EPC STORMWATER REVIEW COMMENTS
IN ORANGE BOXES WITH BLACK TEXT

CITY LINK TRUCKING

Grading & Erosion Control Plans

PCD File # PPR2339

SITE GRADING AND EROSION CONTROL PLAN

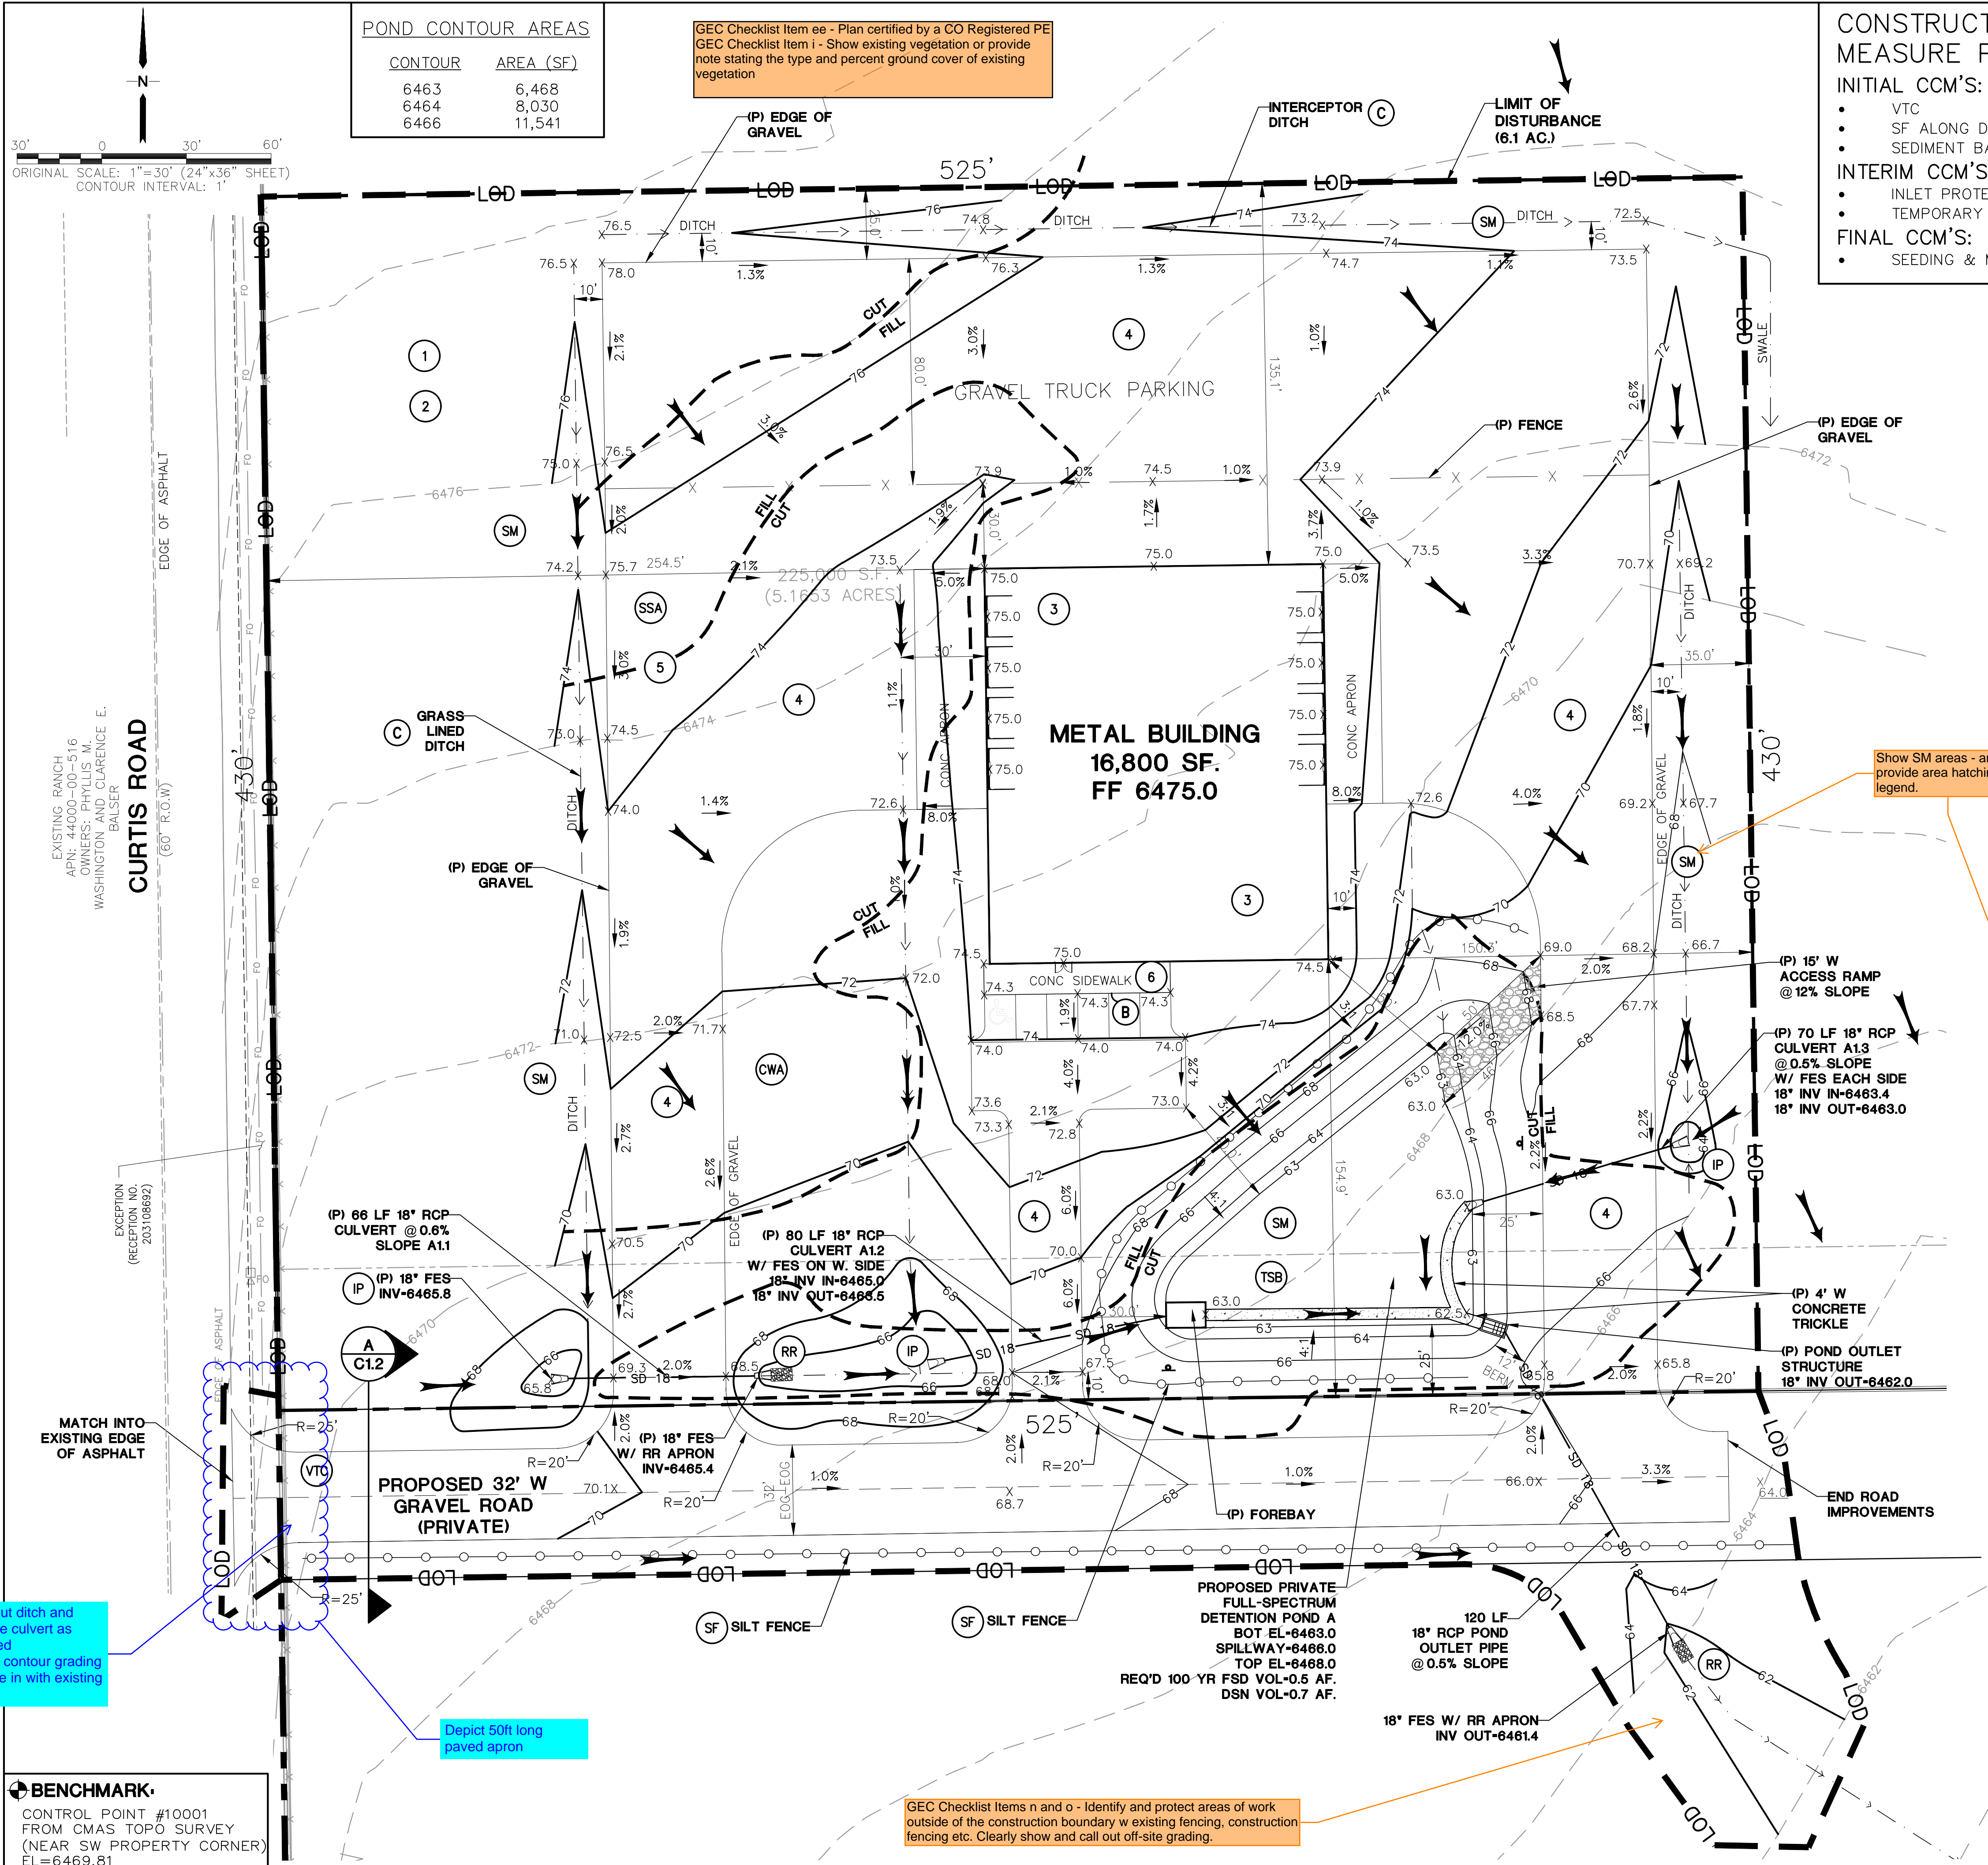
Call out ditch and denote culvert as needed. Show contour grading and tie in with existing road.

Depict 50ft long paved apron

Where is this? Is C&G being added? Call out on plans

GEC Checklist Items n and o - Identify and protect areas of work outside of the construction boundary w existing fencing, construction fencing etc. Clearly show and call out off-site grading.

TYPICAL CONCRETE CROSSSPAN (1)

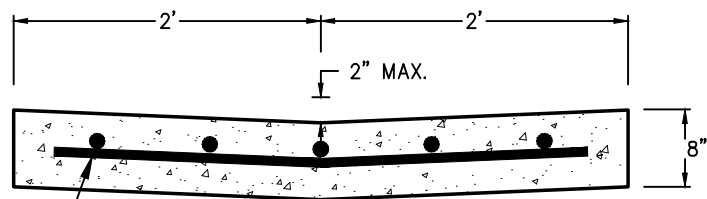
Call out on plans if not applicable then remove

TYPICAL RURAL LOCAL ROADWAY SECTION (A)

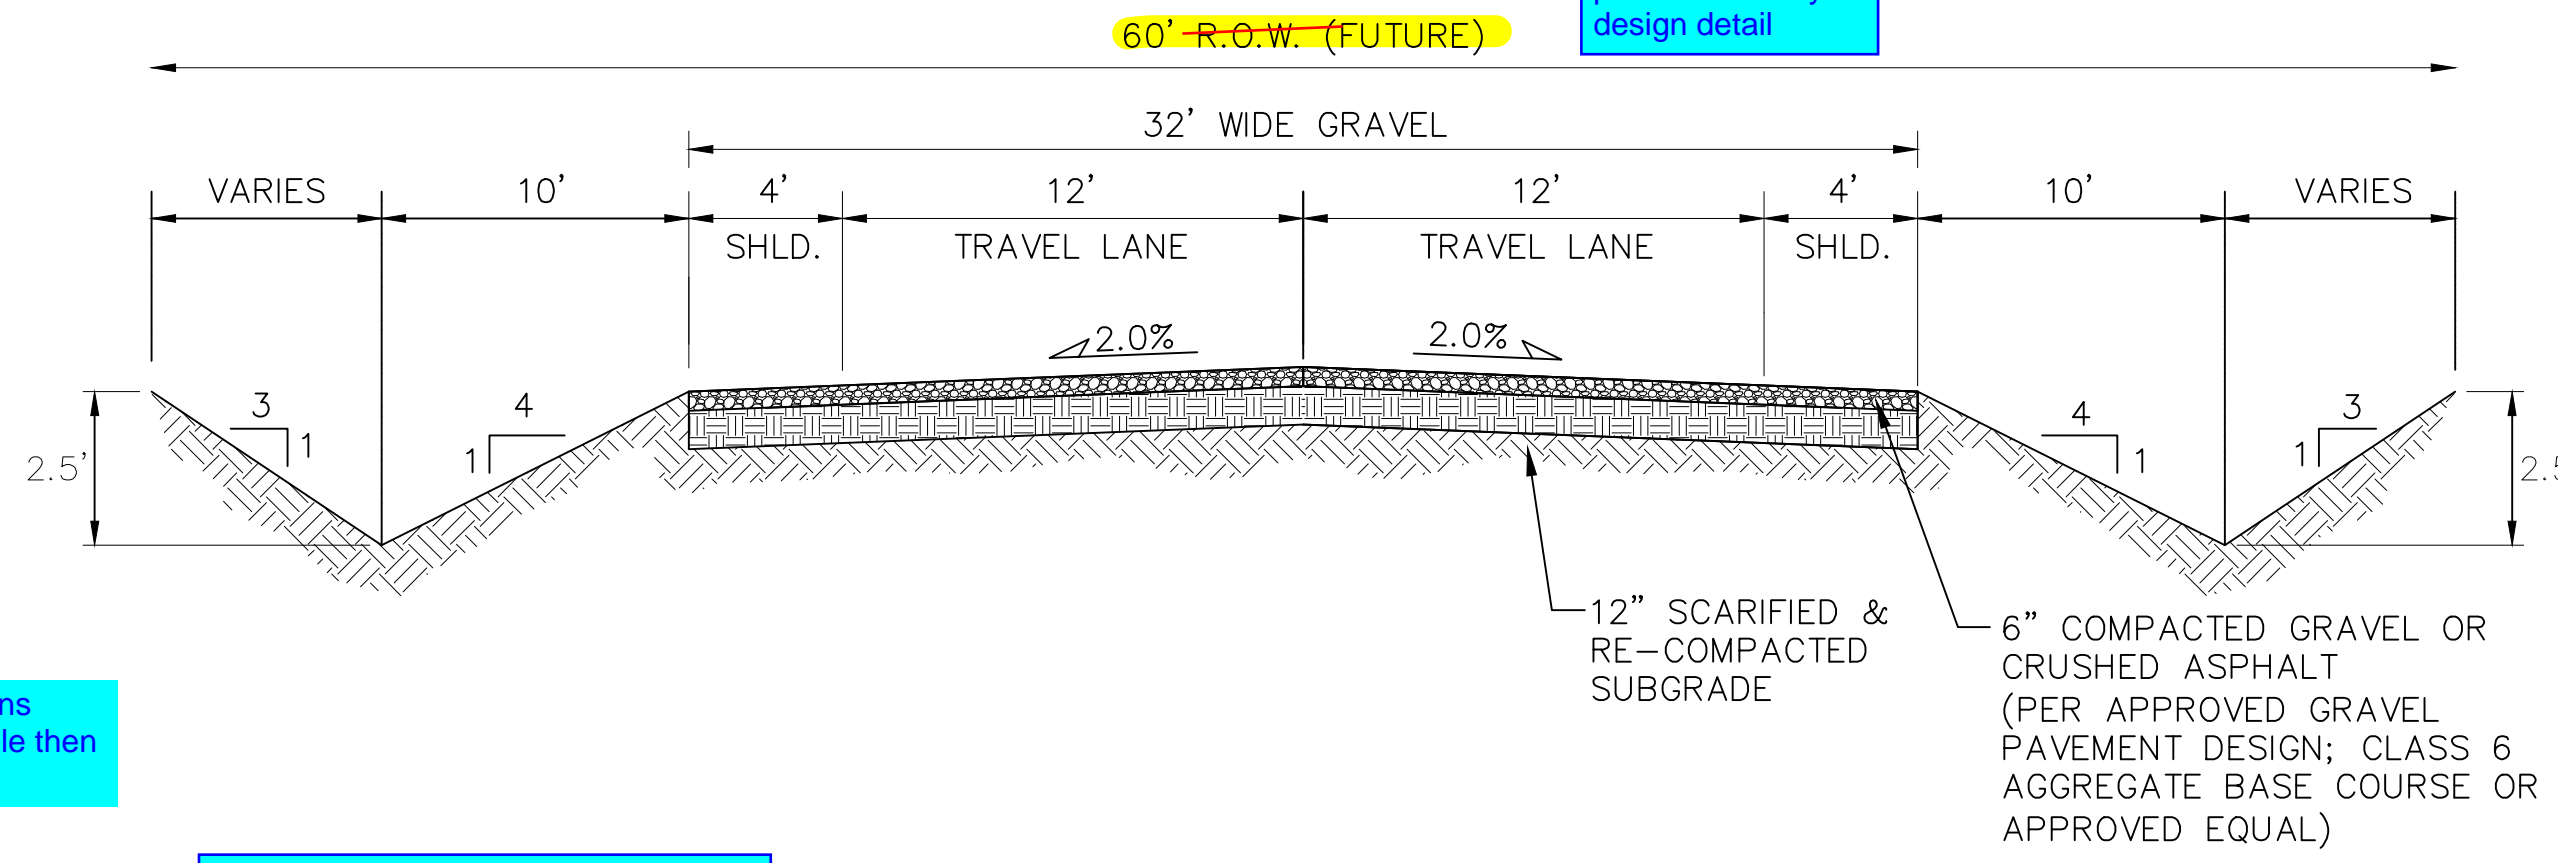
No right of way is being platted. If this is how the driveway will be constructed then just label as private driveway design detail

Is a private driveway or private road being constructed? Please clarify in the LOI if a private road is being built

HANDRAIL DETAIL (C)

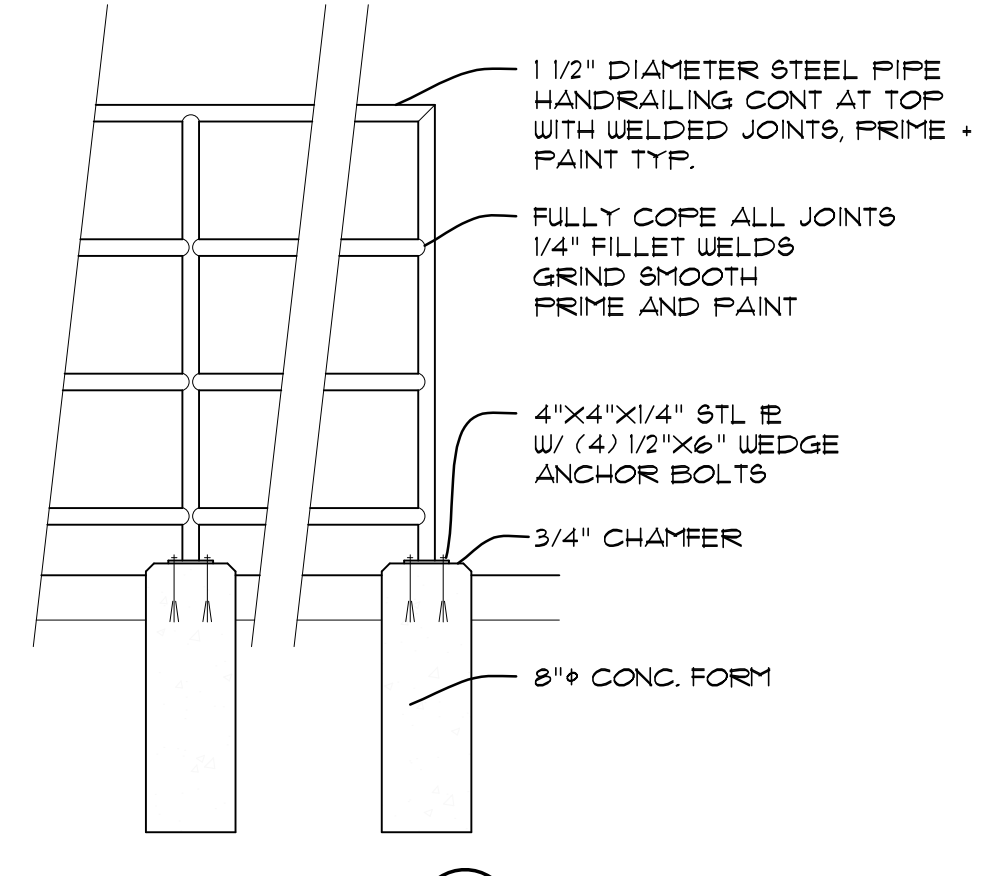
Where are these on the site plan? Please call out or remove if not applicable

**ORIFICE PLATE AND TRASH RACK
DETAILS AND NOTES (B)**

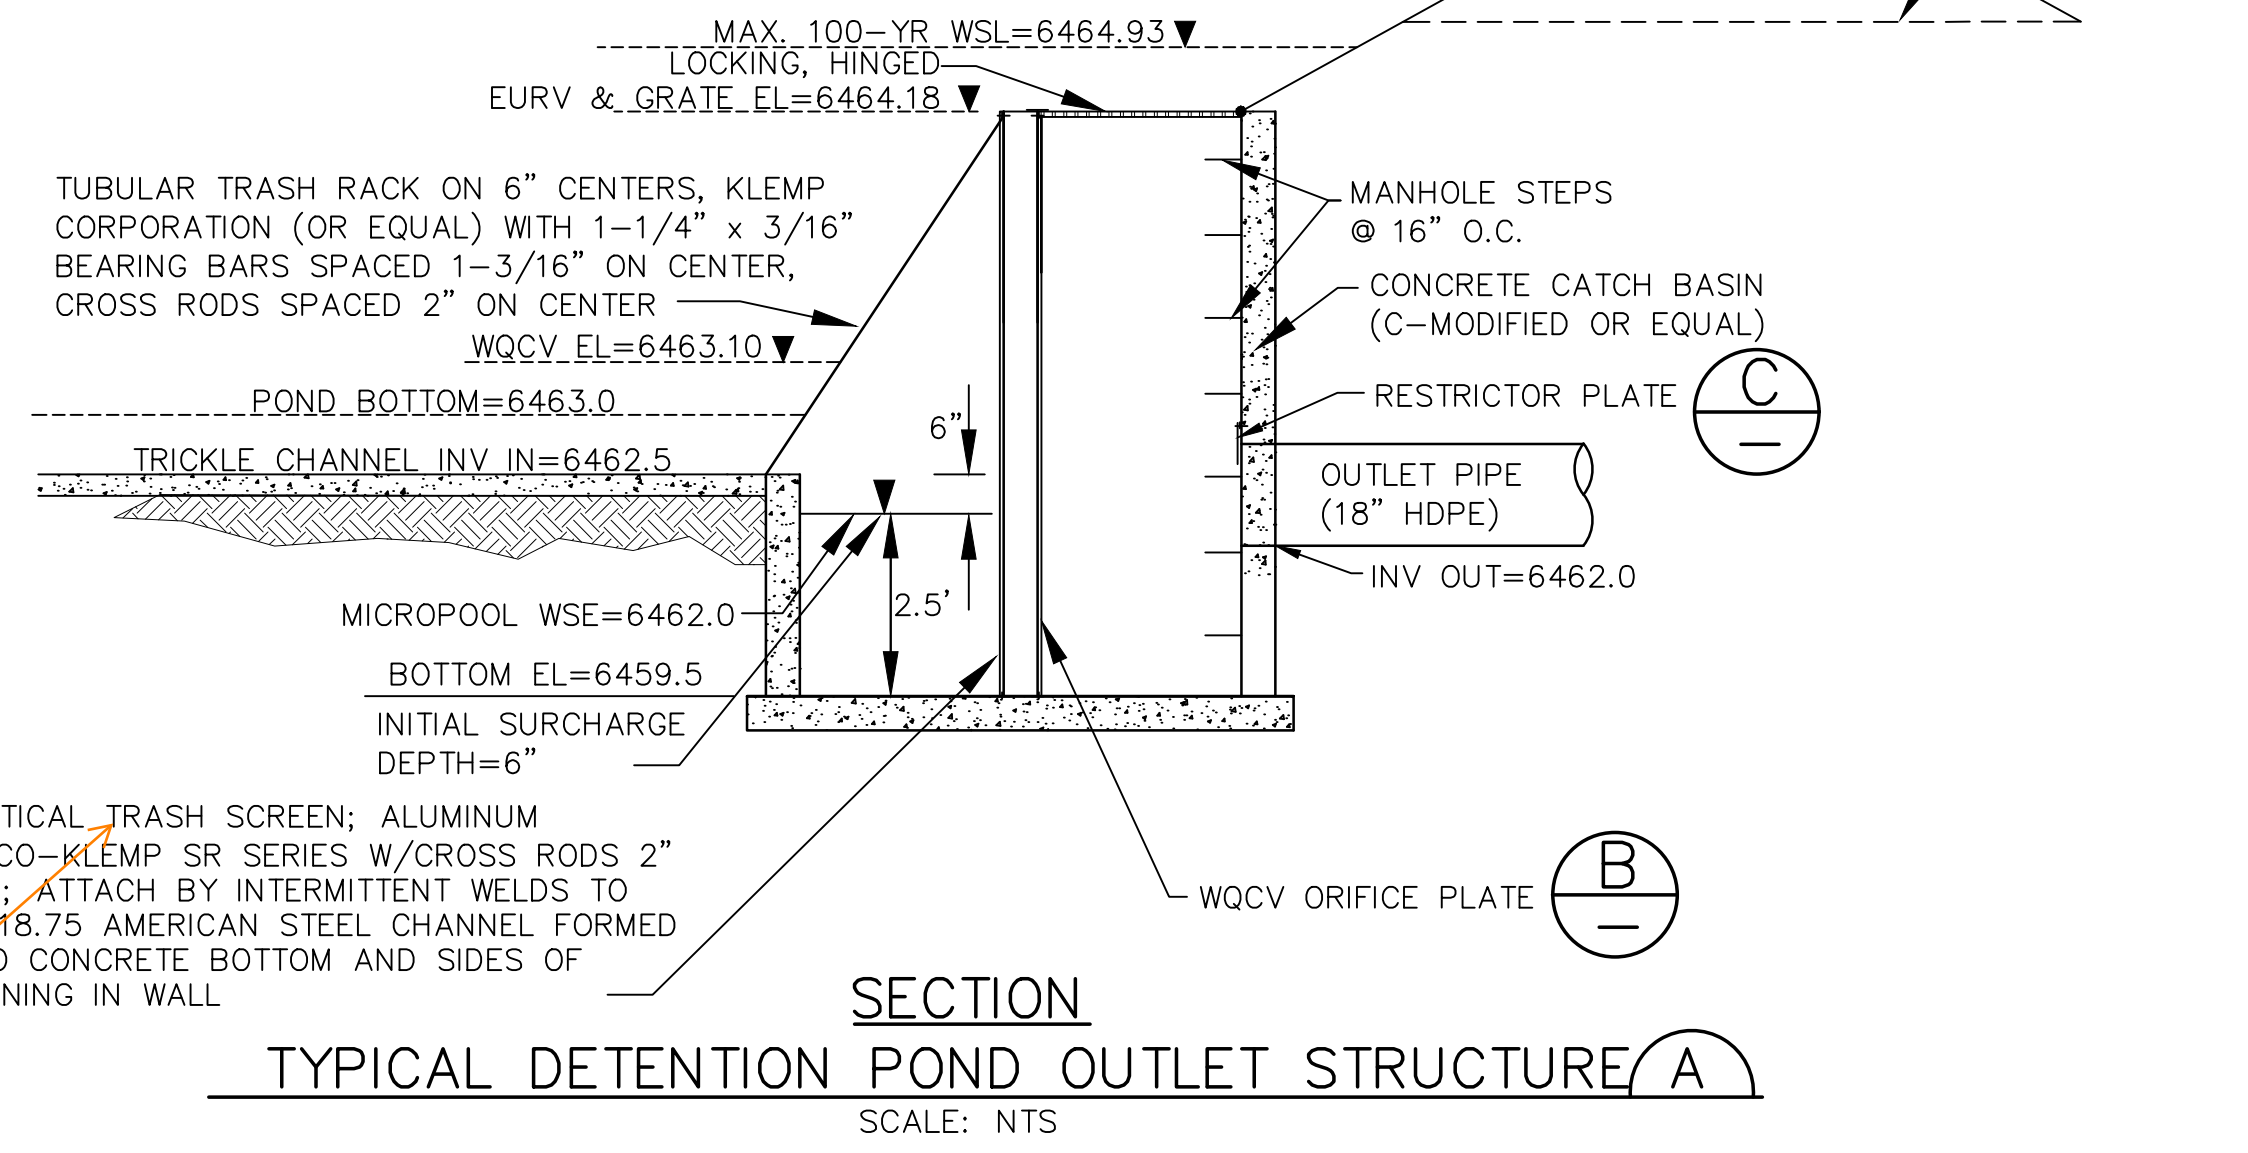
The orifice trash screen should not be a bar grate style for orifices holes <math>< 1-3/16''</math>. Well screen trash screens would be more appropriate. The minimum openings of the bar grate must be smaller than the orifice opening.
